Please replace the last paragraph at page 15, lines 16-22 and page 16, lines 1-4 of the specification with the following paragraph:

In the Drawings

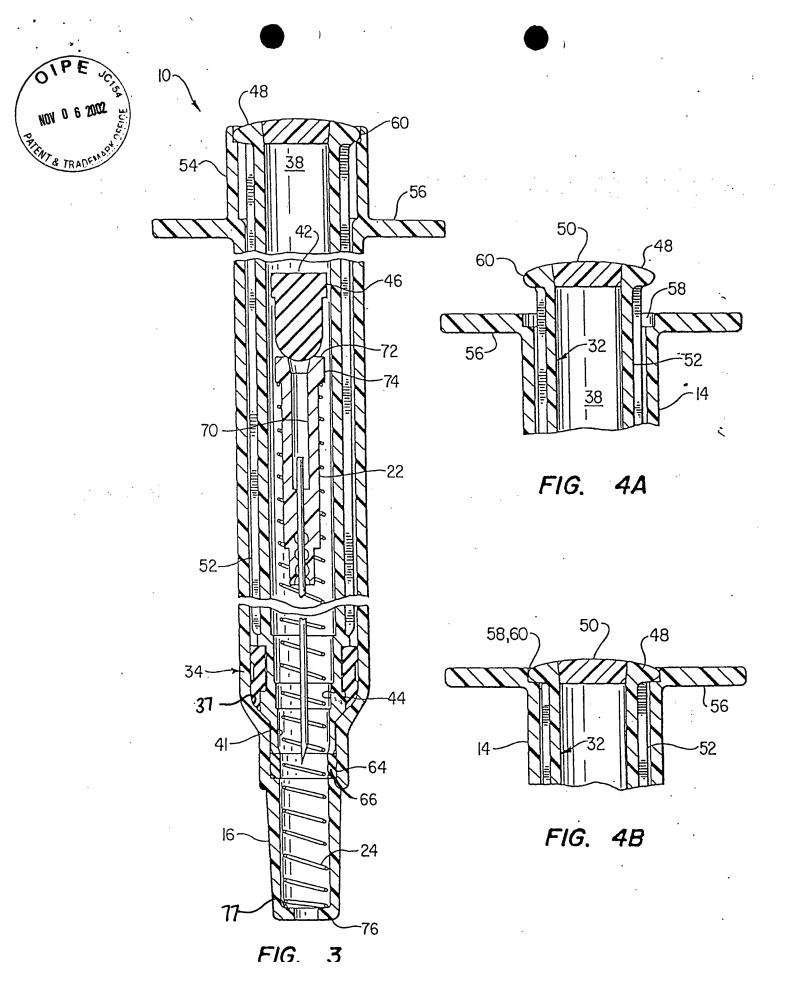
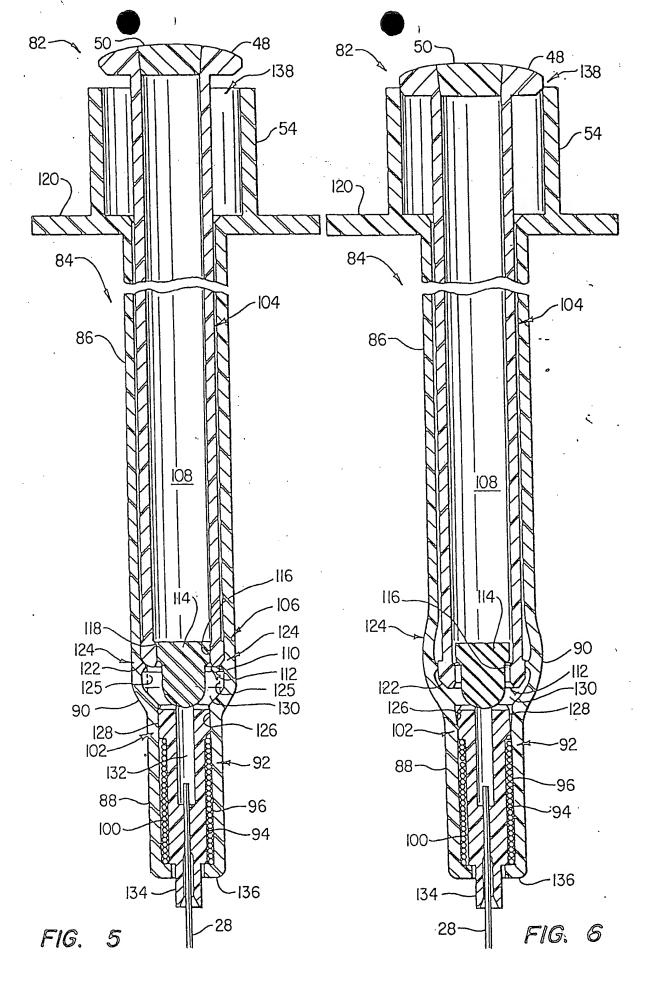
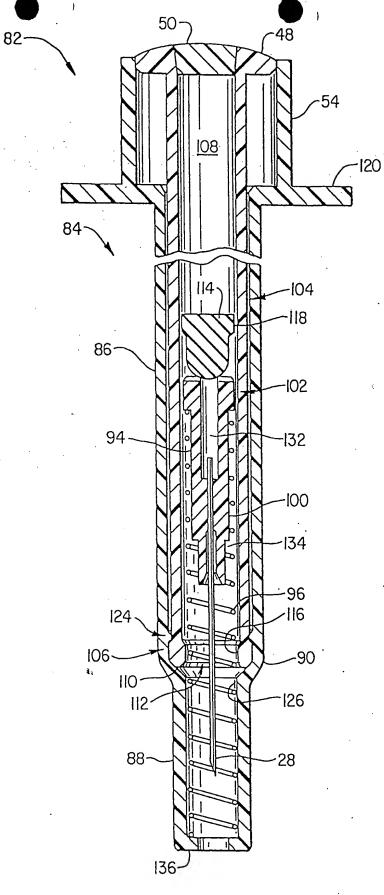
FIGS. 1-3 are submitted for approval by the Examiner. As indicated by red ink hand corrections on FIGS. 1-3, the lead lines to reference numeral 66 have been changed to particularly point out the continuous retaining member, thereby preventing the appearance that reference numerals 64 and 66 point to the same part. Approval is requested.

As indicated by red ink hand corrections on FIG. 2, reference numeral 49 has been added to particularly point out the means of force applied by the tip of the plunger. Approval is requested.
